## Product Change Notice (PCN)

**PCN Number:** PCN-0334008R-01

**CMC-5044PF-A**

#### CMC-5044PF-A

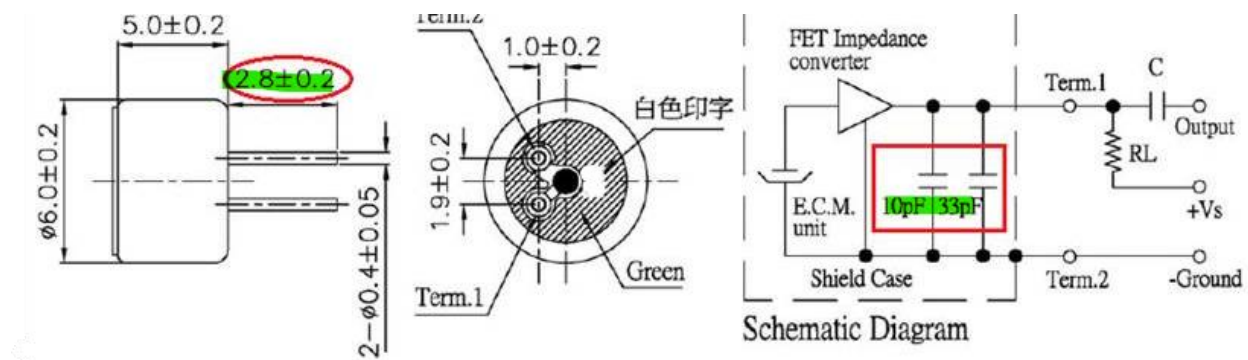
To ensure lead times are not being extended with shortage of material we have changed to a new PCB supplier and will be using a PCB with a 2.8 mm pin length and a 10pf + 33pf capacitor. Adding the two additional capacitors will be helpful on anti-interference at high frequency.
